## Steel Joist Institute Bolted Anchorage Requirements for Joist or Joist Girders with Net Uplift

With the release of the 43<sup>rd</sup> edition Standard Specifications for steel joists and Joist Girders Vulcraft would like to notify our customers of some important changes in regards to the required end anchorage for uplift conditions.

**Figure 1**

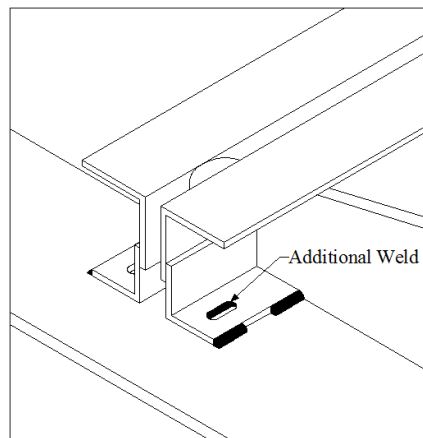
When bearing seats have been detailed for a bolted condition, the bolts should be installed. “If bolts are not installed, an equivalent welded connection may be permitted by the specifying professional, provided the weld is deposited in the slot on the side farthest from the edge of the seat.” See Figure 1 below (ref. 43<sup>rd</sup> SJI p. 13)
